RESOLUTION NO. 1371

A RESOLUTION ADOPTING FINDINGS APPROVING A MODIFICATION TO THE STAGE I PRELIMINARY PLAN, VILLAGE AT WILSONVILLE MASTER PLAN (CHARBONNEAU), STAGE II FINAL PLAN, CONDOMINIUM PLAT, AND REMANDING SITE AND DESIGN PLANS FOR DEVELOPMENT OF ATTACHED HOUSING. THE SITE IS LOCATED ON VARIABLE PROPERTY "A" IN CHARBONNEAU VILLAGE CENTER ON TAX LOT 8000A, SECTION 24CD Supplemental No. 2, T3S-R1W, CLACKAMAS COUNTY, OREGON. WILLAMETTE VALLEY HOMES/CHARBONNEAU VILLAGE CENTER CONDOMINIUM ASSOCIATION, APPLICANTS. CASE FILE NO. 97DB03

REQUEST: 97DB03: Willamette Valley Condominiums.
Modify the Stage I, Village at Wilsonville Master Plan (Charbonneau) , approve Stage II, Final Plan, Condominium Plat and Site and Design Plans for development of attached residential housing. An approval of this request would rescind and replace the parking lot approved in Resolution 95DR12.

TREE REMOVAL SIDEWALK RELOCATION

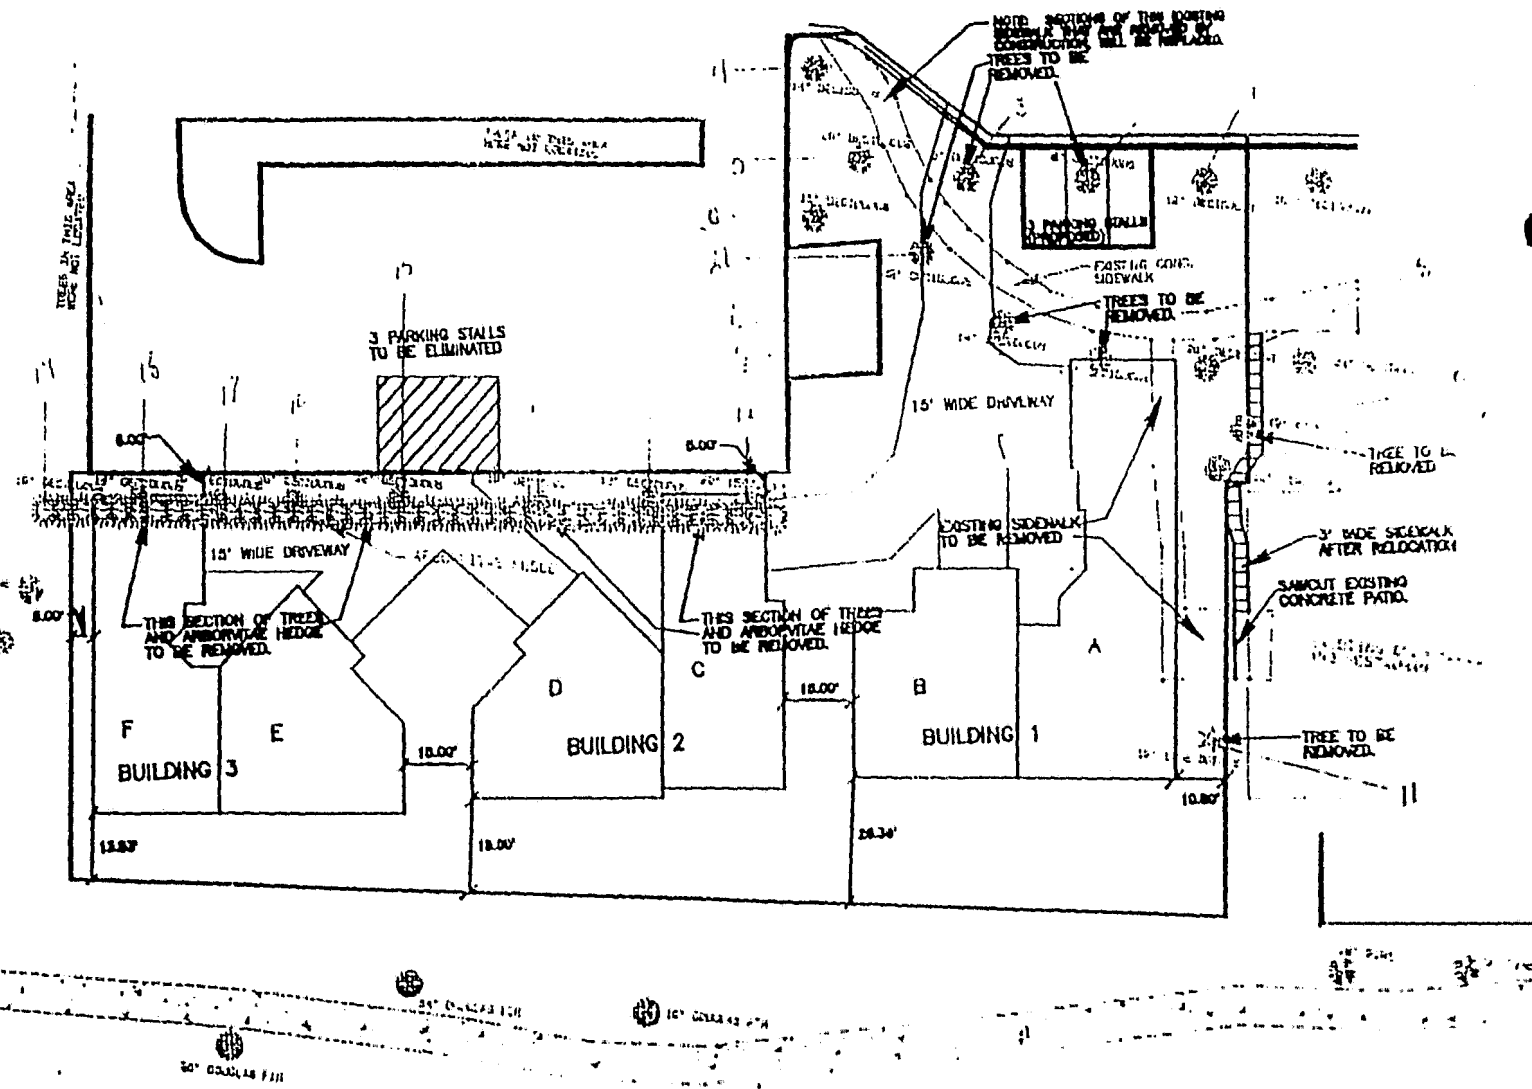
The Trees consist of: Oaks, Sycamores, Maples, Deodora Cedars and one Blue Atlas. The existing Arborvitae Hedge, is also slated to be removed due to plan design, and will be replaced during the re-landscaping portion of the project. The current Arborvitae Hedge has reached maximum growth height at which failure of major leaders begins to occur.

I have also numbered the trees shown on the plot plan to coincide with the numbers on the trees.

Trees numbered 12 - 19 in addition to competing, with the arborvitae's are also competing with ground cover (ivy) for needed nutrients. These trees show signs of bacterial and other infectious cankeral growths. The need for root pruning in order to avoid damaging existing hardscapes, will make these trees highly susceptible to fungal diseases that are lingering in the area. I recommend removal of these trees in order to ensure disease free planting environment upon completion of the project.
